Plan Change 58: Avenue Business Park  
Further Traffic Information

This letter provides responses to matters raised in the traffic peer review letter prepared by Gray Matter dated 16 March 2023. This letter is intended to be submitted as part of a broader response to the further information request from Matamata-Piako District Council (MPDC) dated 21 March 2023 for Plan Change 58 (PC58) which identifies the need for the Applicant to respond to matters raised in the Gray Matter peer review (amongst other items).

SUBTITLE: PROPOSED AVENUE ROAD NORTH INTERSECTION PLAN

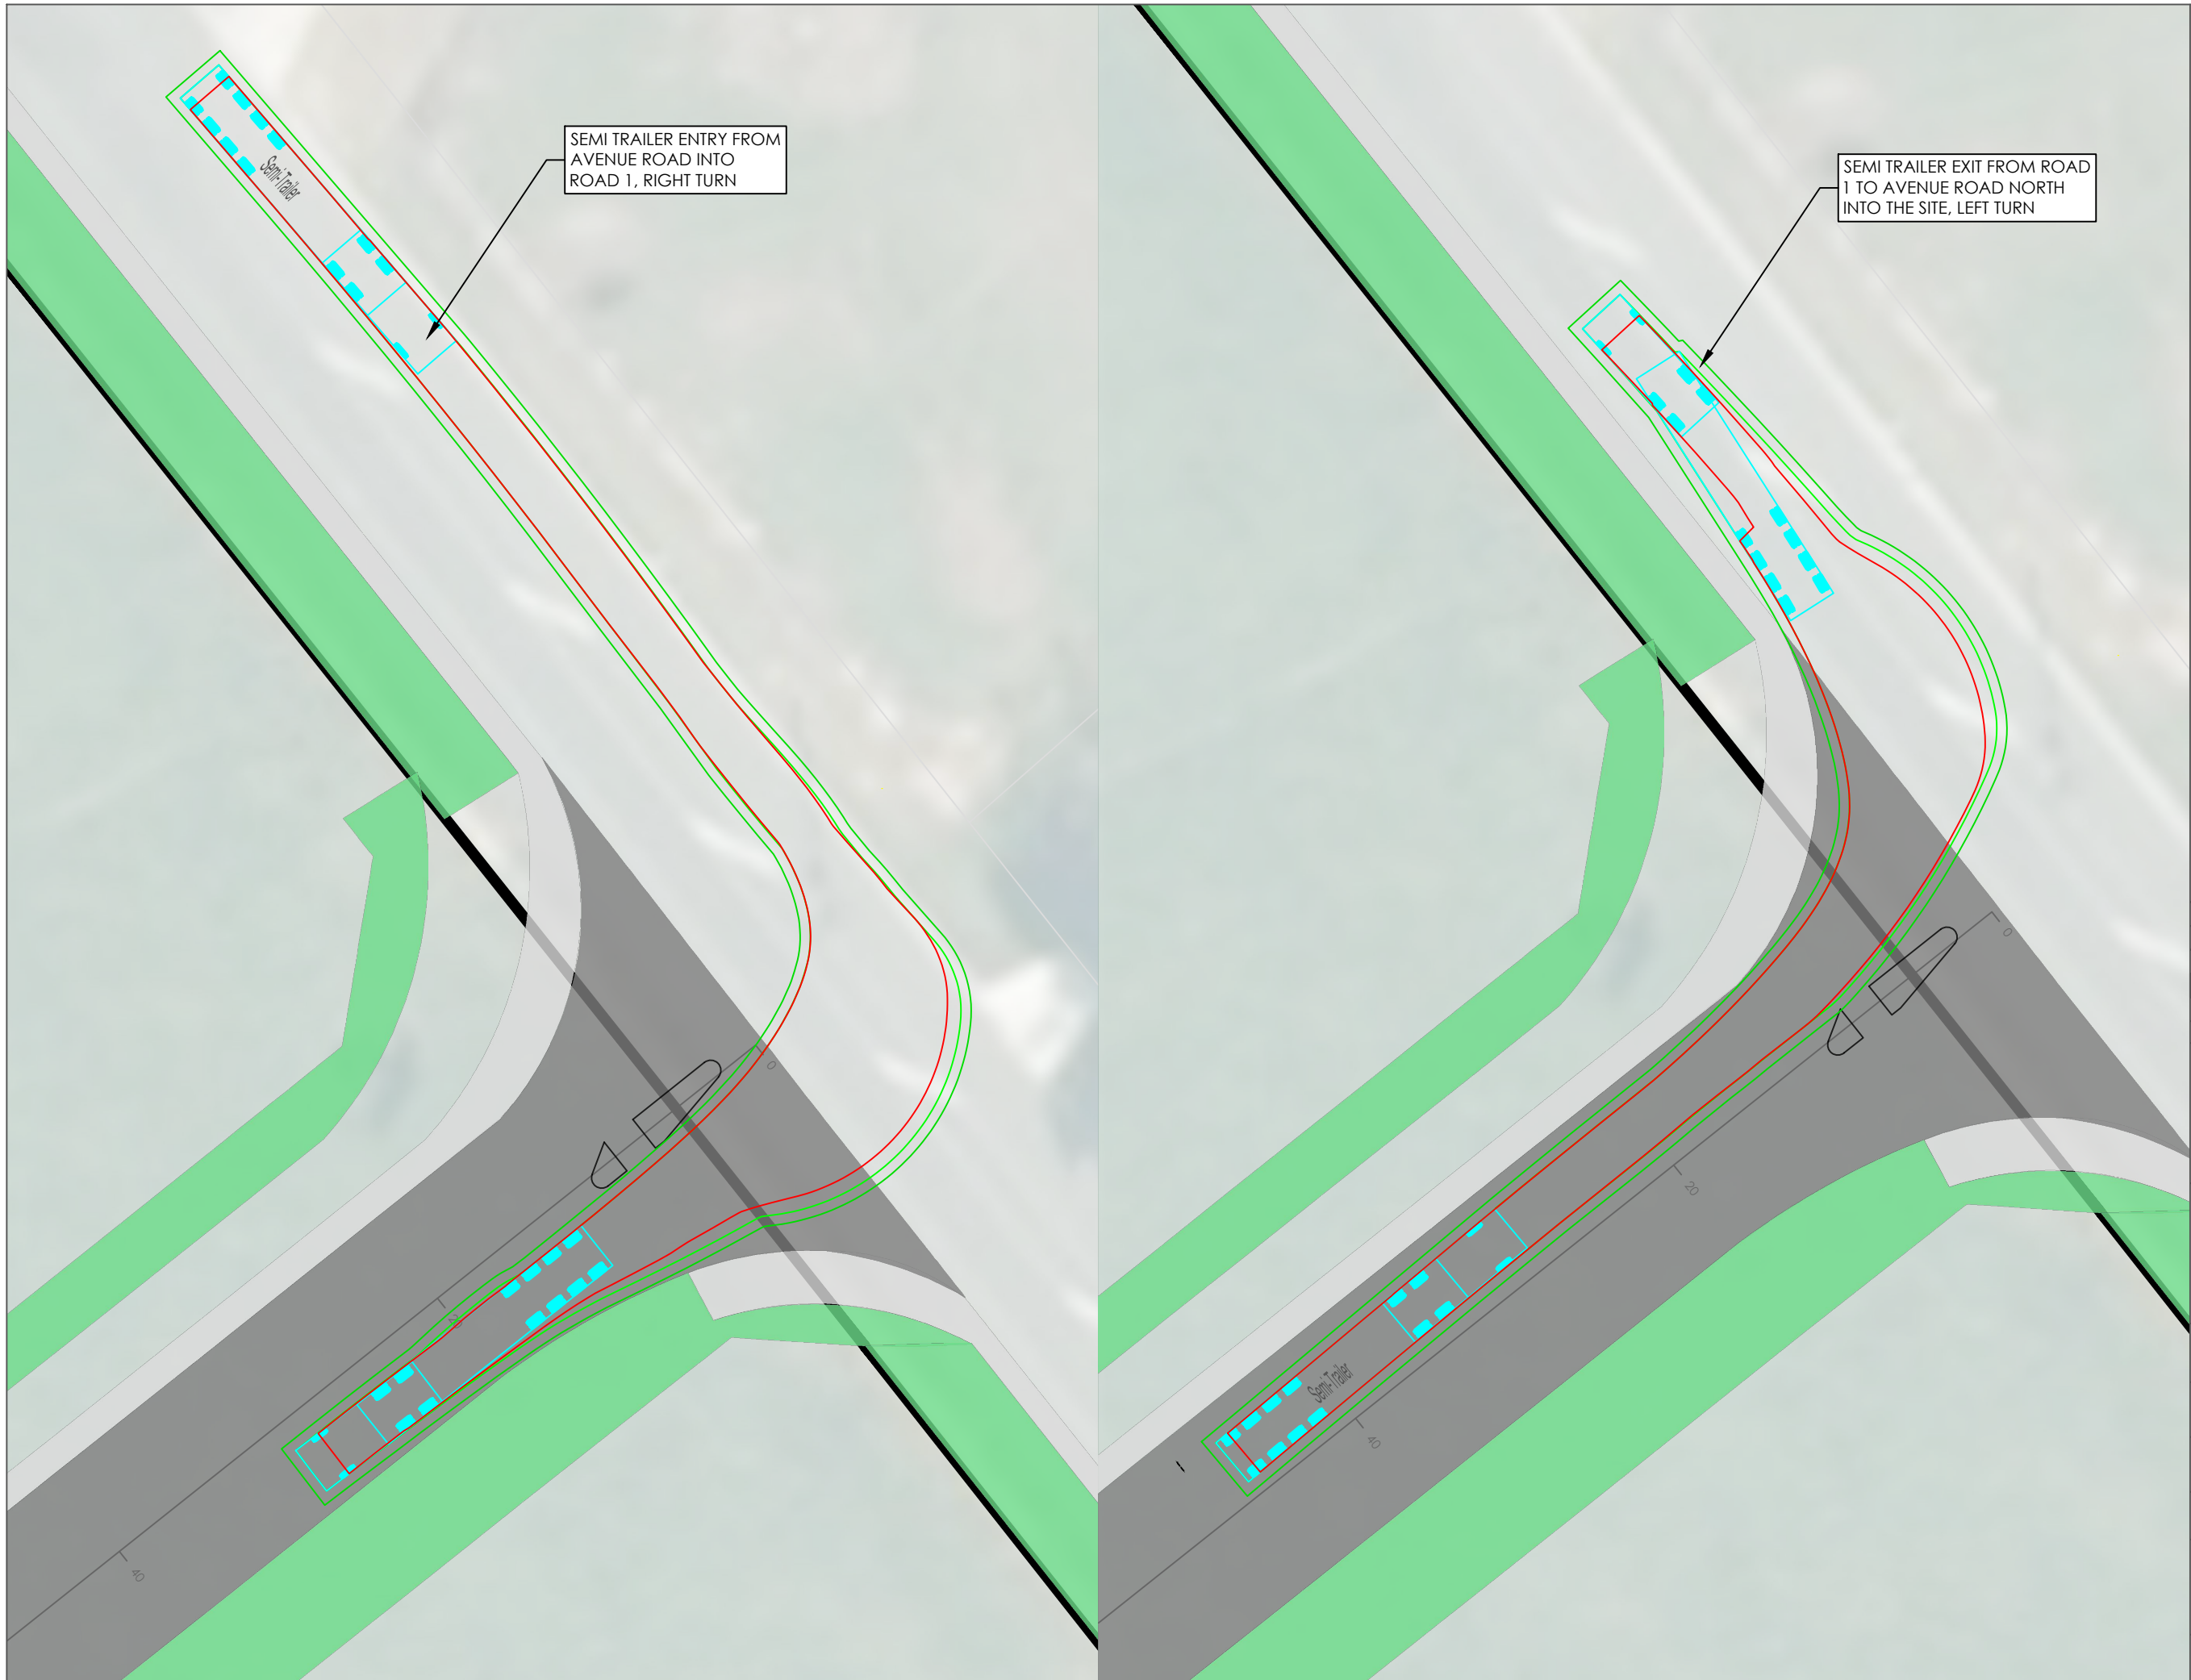
Issue Raised by Gray Matter. Numbering is as per the Gray Matter letter of the 16 <sup>th</sup> March 2023.		Applicant's Preliminary Comments	Meeting Discussion/Outcome
4	Design of the Stage 1/Avenue Rd North intersection	Engineering plans for the intersection have been amended and resubmitted to MPDC. The intersection will be built well ahead of development occurring within the PC58 site.	The engineering drawings which have been approved by MPDC for the Stage 1 subdivision (which is consented and under construction) are attached to this letter.

SUBTITLE:  
**PROPOSED ROAD 1 & 2 CROSS SECTION**

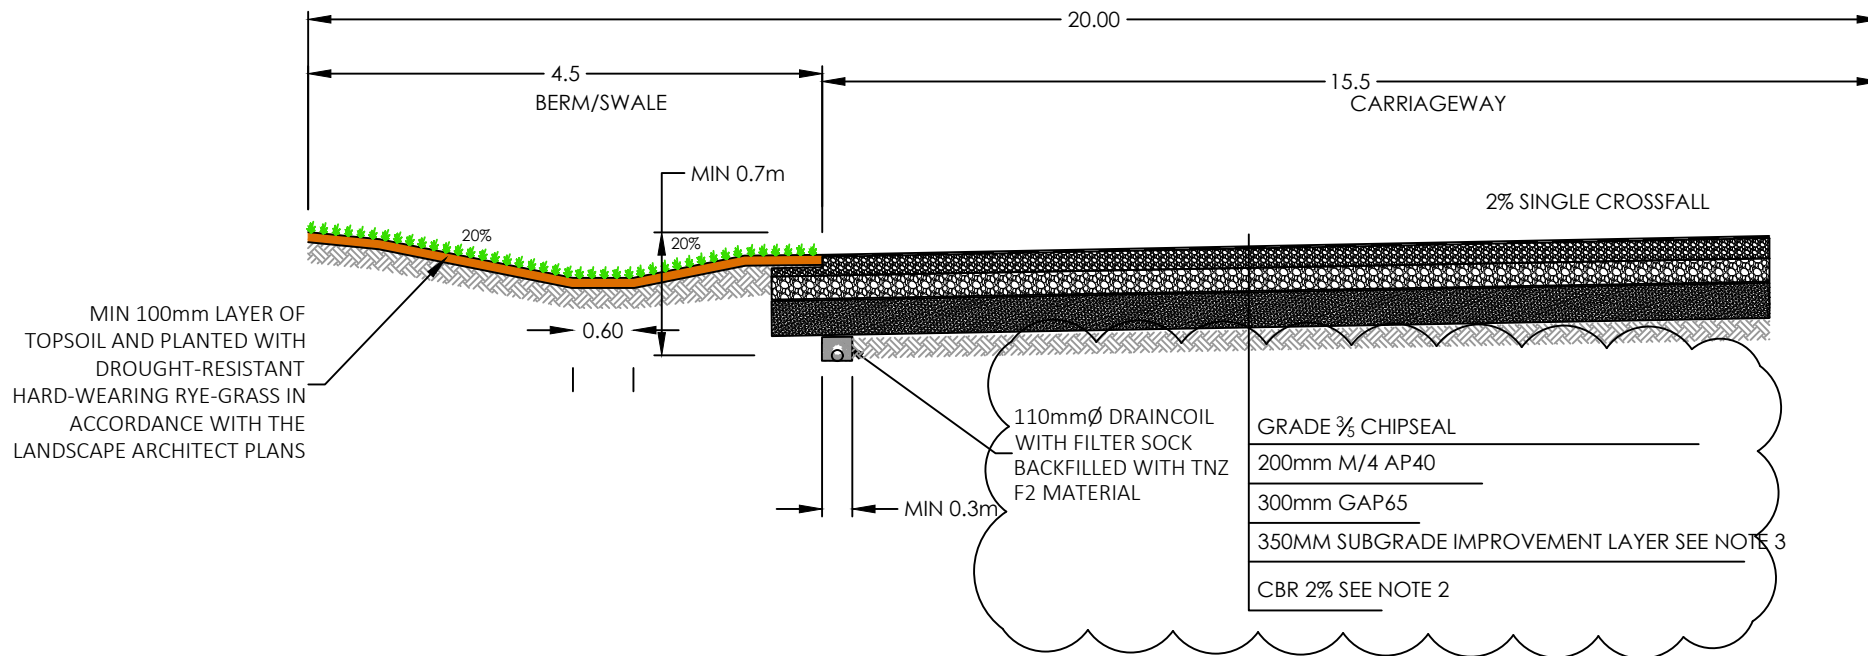
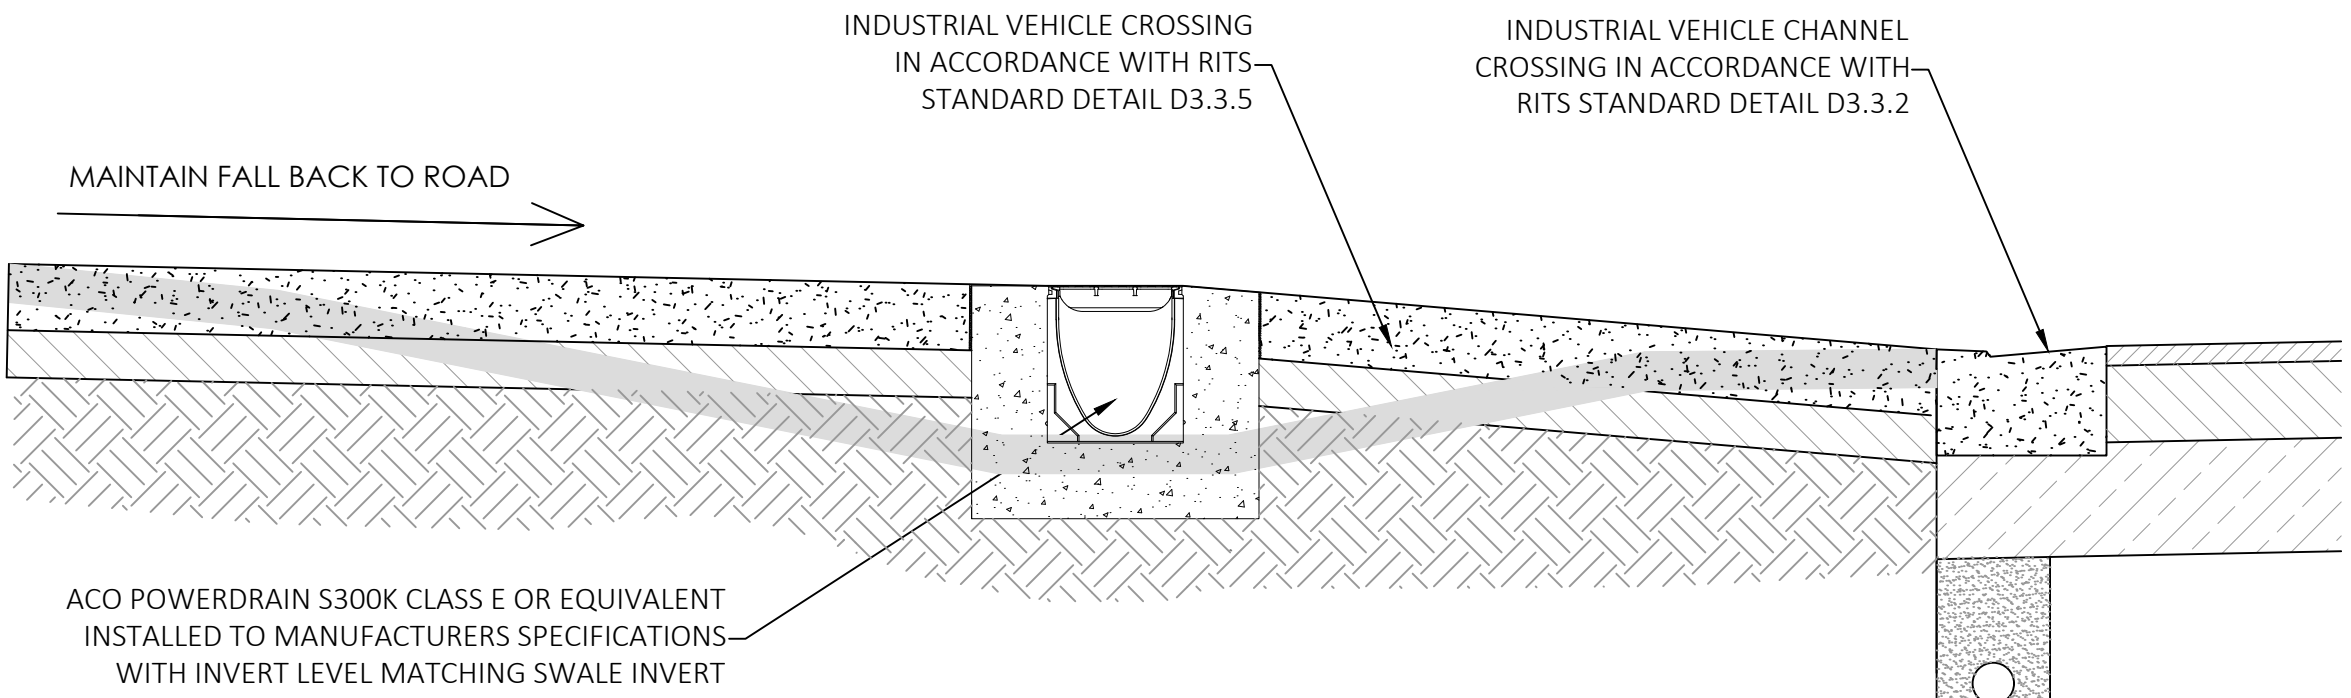
4.2	<p>Updated road cross sections to provide for cyclists, pedestrians and safe turning within the plan change area and to be included in the district plan. A 23-25m width is suggested by Gray Matter for the north-south road to protect a Collector Road function and for the east-west road (including the ABP subdivision site). They recommend a cross section of 20-22m for other local roads</p>	<ol style="list-style-type: none"> <li>A local road standard is all that is required for the north-south road to service development of the PC58 site. If MPDC requires a collector road standard to future proof a connection between SH26 and Hangawera Road then we require confirmation that the additional costs (land and construction) would be met by Council. Recognising there has been very limited consideration to date by MPDC to a bypass, the PC58 provisions should be flexible enough to allow a local road to be built if MPDC subsequently determines that is all that is required.</li> <li>The width and design of the east-west road through the Stage 1 site has been fixed through the approved consent and cannot be changed. Construction is well progressed and adjoining lots have been sold. There is no opportunity to change this now. The PC58 east-west road will match the Stage 1 east-west road to provide consistency.</li> <li>Subject to MPDC's feedback on (1) above, we will consider the suggestion of including cross sections in the district plan.</li> </ol>	<p>The Applicant's position for all roads is a 20m road reserve with provision for this width to be increased for the north-south road to a wider collector road standard at a later date prior to any subdivision if it is required. Council advised they will consider this. The updated provision is Appendix 9.6.1(c):</p> <p><i>9.6.1 (c) All public roads within the ADAP shall be constructed to local road standard with a minimum 20m wide road reserve width, 10m wide carriageway and 1.5m footpath on one side, unless the north-south aligned road is required to be constructed to a collector standard and:</i></p> <ol style="list-style-type: none"> <li><i>MPDC has confirmed it is required to be constructed to collector road standard to provide a wider connectivity function and/or to service growth in the wider area; and</i></li> <li><i>Council funding has been confirmed to meet the costs of the necessary upgrading from local road to collector road standard.</i></li> </ol> <p>Gray Matter would still like cross sections to be included in the provisions for the district plan. The Applicant would rather not include cross sections due to concerns that this would be too prescriptive, and that drainage requirements have not been determined,</p>

Issue Raised by Gray Matter. Numbering is as per the Gray Matter letter of the 16 <sup>th</sup> March 2023.	Applicant's Preliminary Comments	Meeting Discussion/Outcome	
			<p>creating uncertainties in the layout. The Applicant would prefer to describe minimum outcomes for the road reserve width, carriageway width and footpaths in the district plan provisions instead. This has been addressed in proposed changes to Appendix 9.6.1(c).</p>
